Revised January 28, 2019
January 18, 2019

Re:*Proposed Leonidas Group of Virgil, LLC Starr Road Residential PUD Site Plan Review
SEQR Review Part 2 & 3
Tax Map No. 96.10-1-19.1
CHA Project No. 19646.5005*

LAND USE: 220 - Multifamily Housing (Low-Rise)

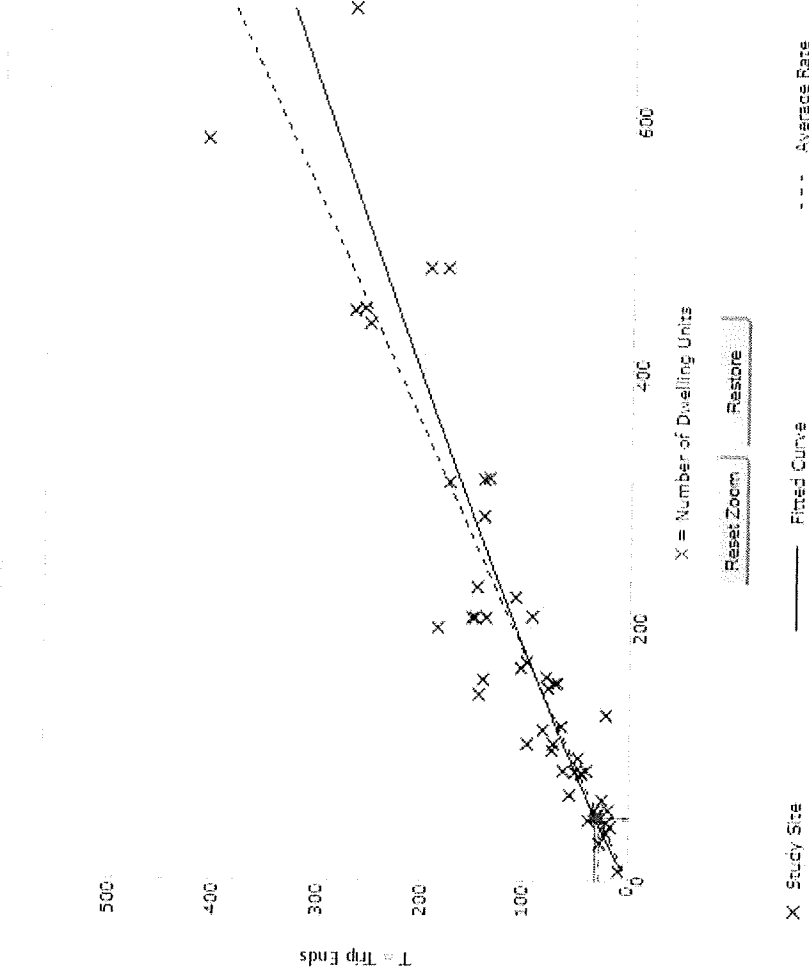
The Applicant has stated that an additional 31 vehicle trips will be added to the Starr Road roadway network. The source/edition of the trip generation data that the Applicant provided is not referenced, but the rates are not consistent with the current 10th edition of the Institute of Transportation Engineers (ITE) Trip Generation Manual (TGM). The current ITE data for a proposed multi-family use produces a calculation of 32 trips during the peak hour (see attached). However, the actual difference for the proposed multi-family use is not significant when applied to this proposed project, such that the 31 trips noted in part 1 of the SEQRA FEAFF is a reasonable estimate for the project.

The directional distribution of the PM peak hour trips should also be at 65% enter and 35% exit, and not at 67% enter and 33% exit as shown in the Trip Table provided by the Applicant. Since the total estimated volumes are low for this project, this difference of enter/exit distribution is not significant.
